SERVICE INFORMATION LETTER NO. 0148

1. SUBJECT: Low Rotor Speed Warning Switch
2. MODEL: F-28F and 280FX
3. EFFECTIVITY: F-28F; All serial numbers equipped with Low Rotor Speed Warning System  
280FX; All serial numbers
4. BACKGROUND:

FIGURE 1

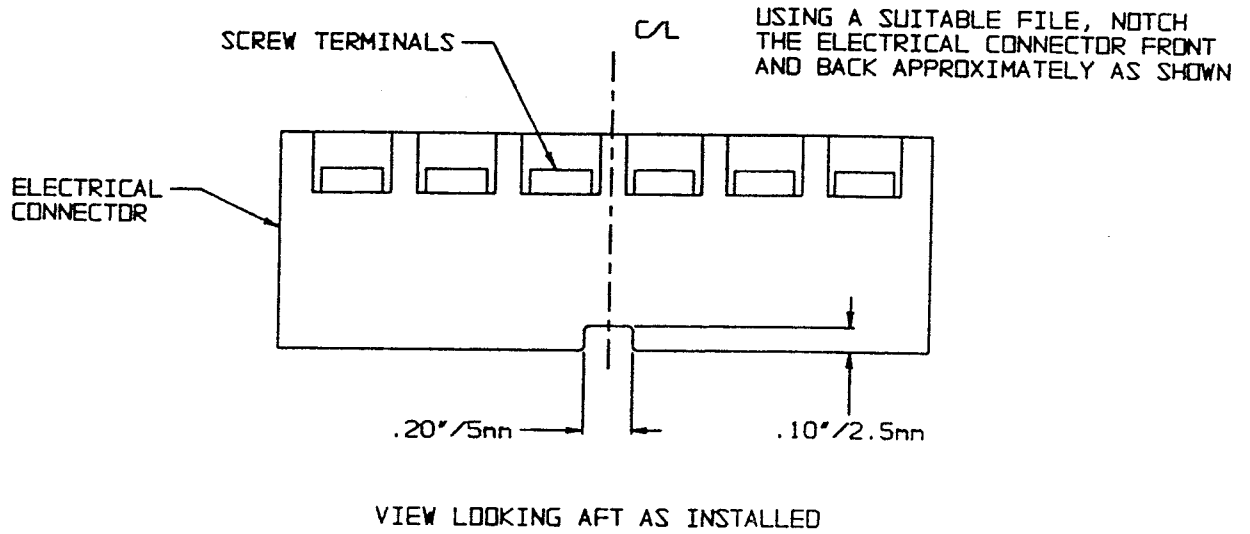
4. Using a suitable file, modify the electrical connector as shown in Figure 1.
5. Reinstall the electrical connector and if required, reconnect the wiring.

FIGURE 2

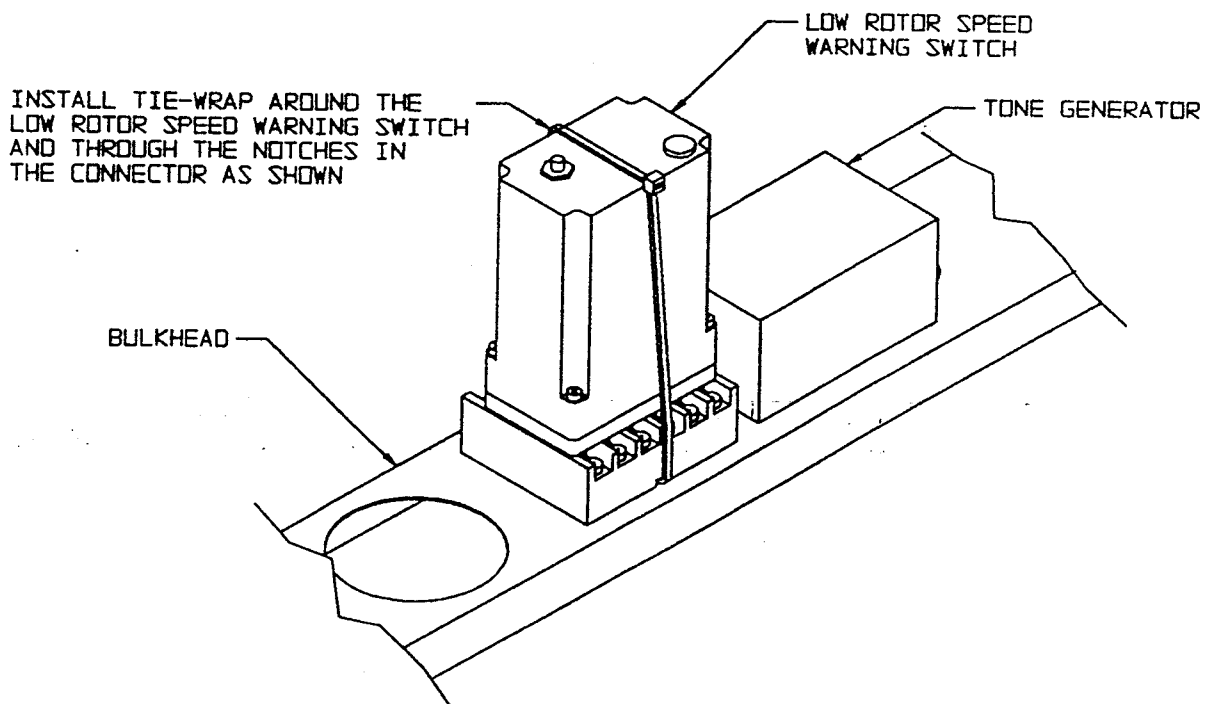
6. Reinstall the low speed warning switch and ensure the switch is fully seated in the electrical connector.
7. Install a tie wrap, P/N WIT-18X, around the low speed warning switch and through the notches in the electrical connector as shown in Figure 2.
